City of Mississauga Department Comments

File(s): A473.24 Ward: 6

Property Address: 5922 Sidmouth St

The applicant is proposing to legalize an existing driveway requiring variances for driveway width and driveway setback.

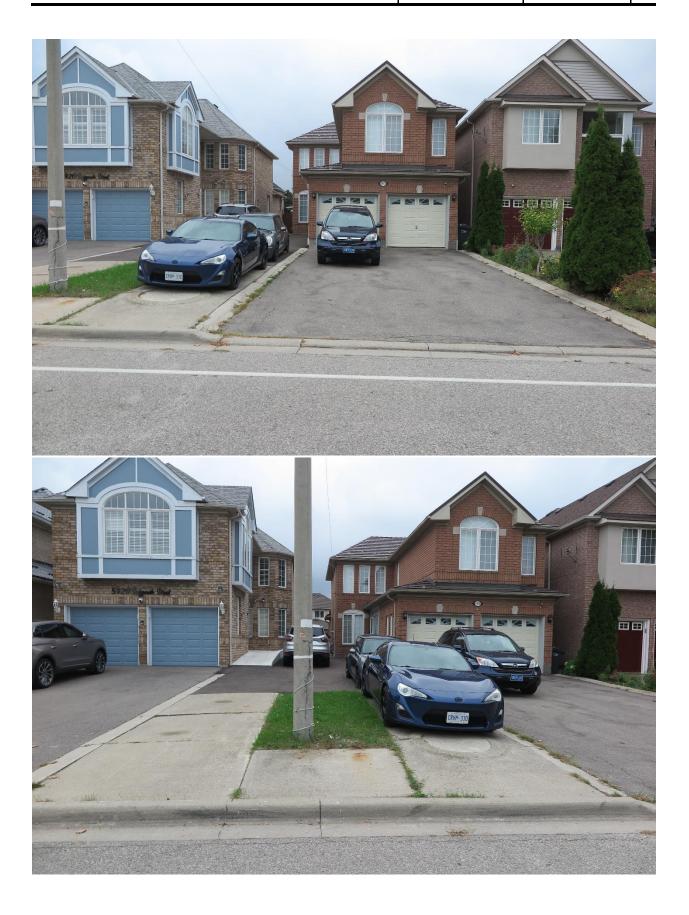
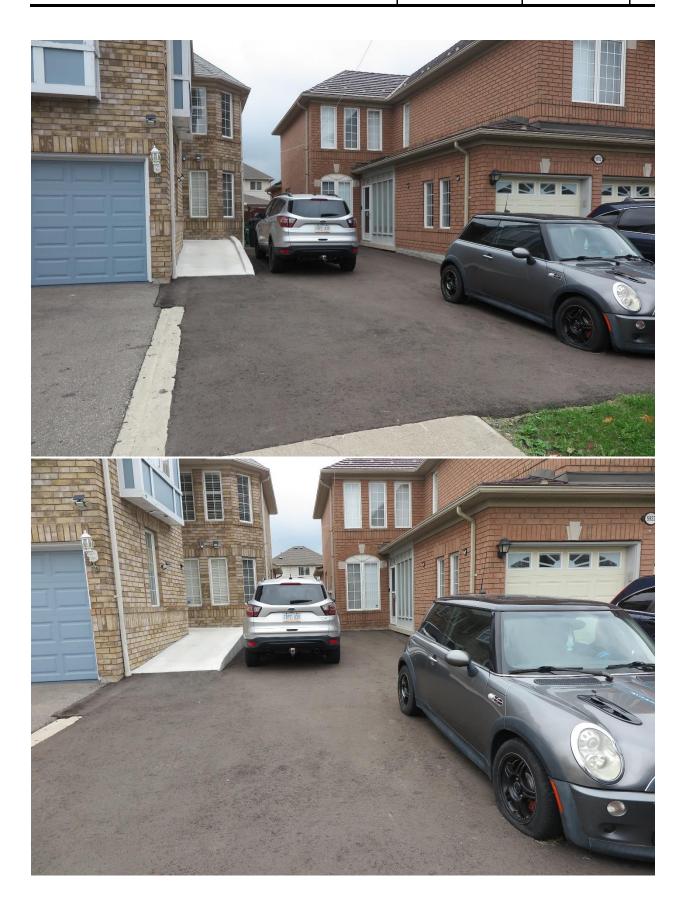
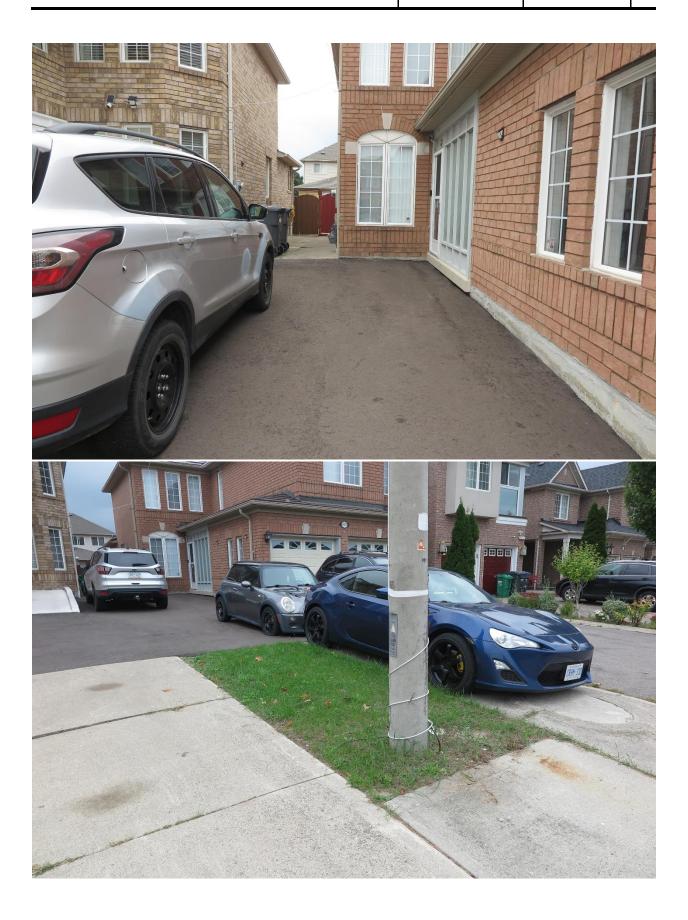
Enclosed for Committee's ease of reference are photos which depict the widened driveway. We are concerned that the additional hard surfacing within the front yard will increase the flow of stormwater into the municipal storm sewer system. Incremental increases in hard surfacing across the neighbourhood and throughout the city have increased pressures and impact on the City's storm sewer system. Lots are typically designed to retain some stormwater through infiltration via permeable surfaces like sodded areas and other landscaped areas.

We also note that the driveway has been expanded in close proximity to an existing concrete streetlight and driveways are required to be located a minimum of 1.5 m from any utility.

This Department does not support the variance as submitted based on the above and recommend that the applicant make modifications to the widened driveway which are acceptable to city staff.

This Department requests that the municipal boulevard (area between the municipal curb and property line) is re-instated with topsoil and a sodded condition.

It also appears that a tree within the municipal boulevard has been removed as a portion of the concrete shows a circle covered with concrete which would have likely been where the municipal tree existed.
